# Rezoning Transportation Analysis

Petition Number: 2021-118

Date	Description
09-23-2021	First Review (KP)
11-22-2021	Second Review (KP)

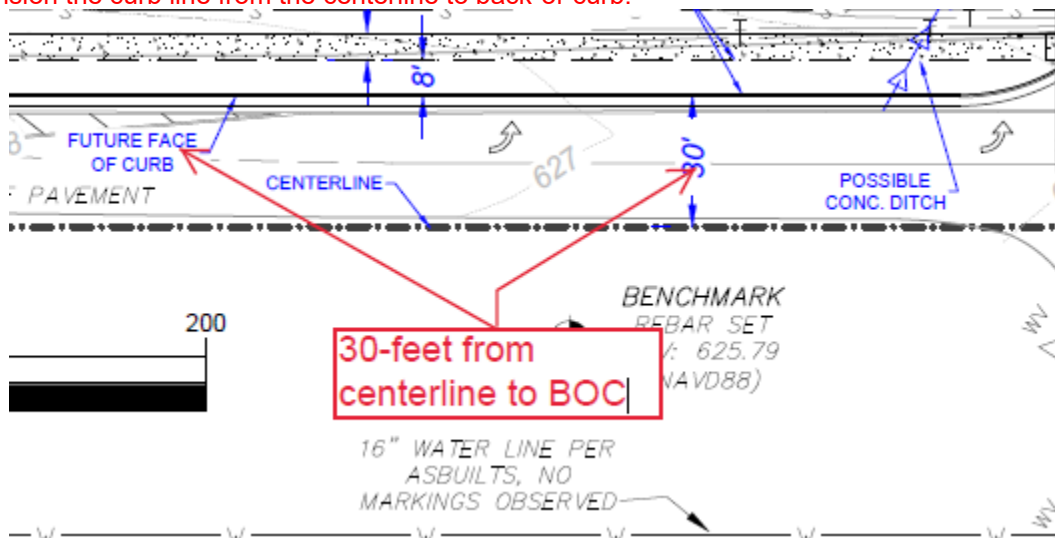
### 1. Curb line:

- a. **Westinghouse Boulevard:** Curb and gutter is not required with this petition; however, the future location of curb and gutter will be 30-feet from the existing centerline measured to the back-of-curb.

Label and dimension the future back-of-curb from the existing centerline.

**Update to Comment as a Result of the 11-15-2021 Site Plan:** Revise the site plan by labeling and dimension the curb line from the centerline to back-of-curb.

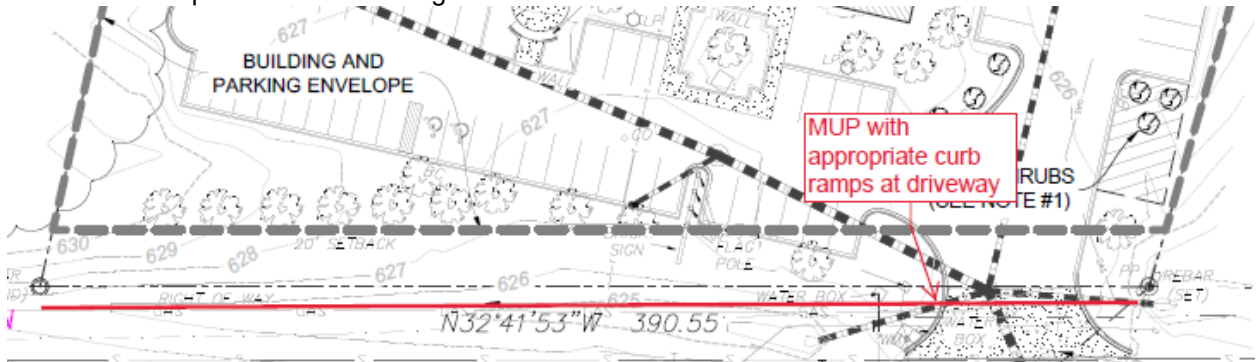
4. **Update to Comment after meeting with petitioner:** An 8-foot planting strip and 6-foot sidewalk will be provided. ~~Revise site plan and conditional note(s) to commit to construct an 8 foot planting strip, and 12 foot shared use path along the site's frontage of Westinghouse Boulevard. This shared use path shall be placed relative to the future curb line location, noted in outstanding issue 1.a, and appropriate~~

ADA curb ramps will be provided across the existing driveway. The site plan shall label and dimension the shared-use path from the existing road centerline.

**Update to Comment as a Result of the 11-15-2021 Site Plan:** Revise the site plan by labeling the sidewalk and planting strip as "proposed".

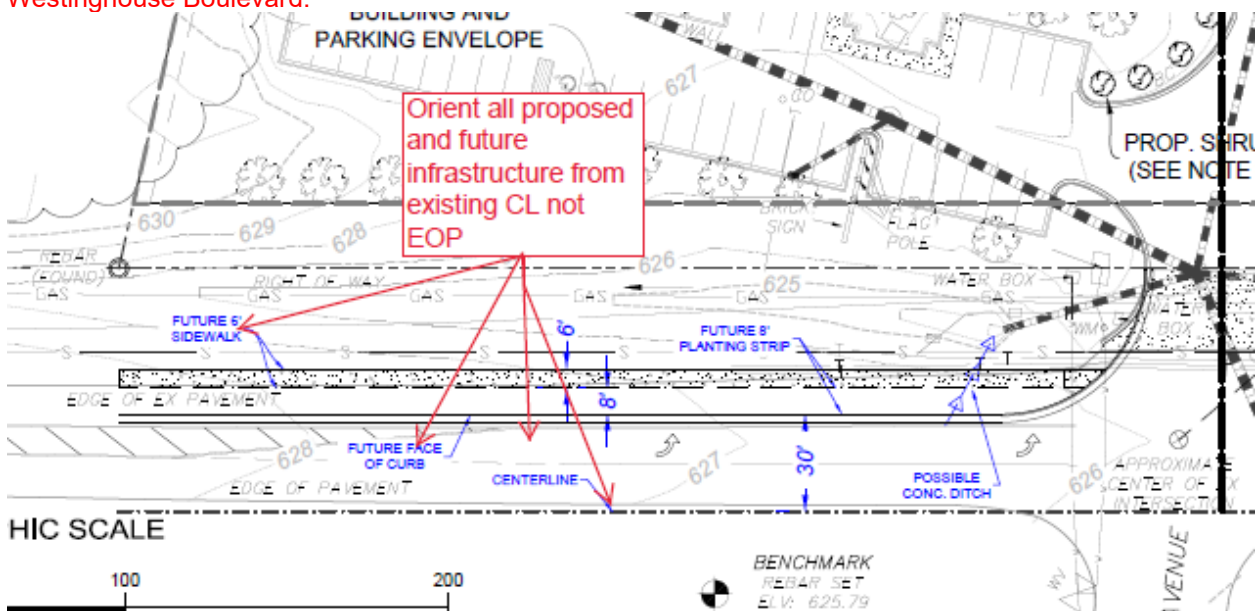
6. A site plan note(s) specifying dedication and fee simple conveyance of all rights-of-way to the NCDOT before the completion of the City of Charlotte's Westinghouse Boulevard Multi-use Path Capital Improvement Project. CDOT requests rights-of-way set at 2' behind back of sidewalk where feasible. **Update to Comment as a Result of the 11-15-2021 Site Plan: Revise the site plan and conditional note 4.c to by including a sidewalk utility easement placed 2-feet behind the proposed sidewalk.**  
depicted on the concept plan for the site.

- c. The Petitioner will commit to commit to dedicate 50-feet of right-of-way from the existing centerline of Westinghouse Boulevard if the existing right of way is not adequate to meet this request.

- d. The Petitioner will commit to construct an 8-foot planting strip and a 6foot sidewalk along the site's frontage of Westinghouse Boulevard. The location of these elements will be measured as 30' from the existing curb with the 8' planting strip and **2-foot SUE placed behind sidewalk.** 30' to the future back of curb behind and immediately adjacent to
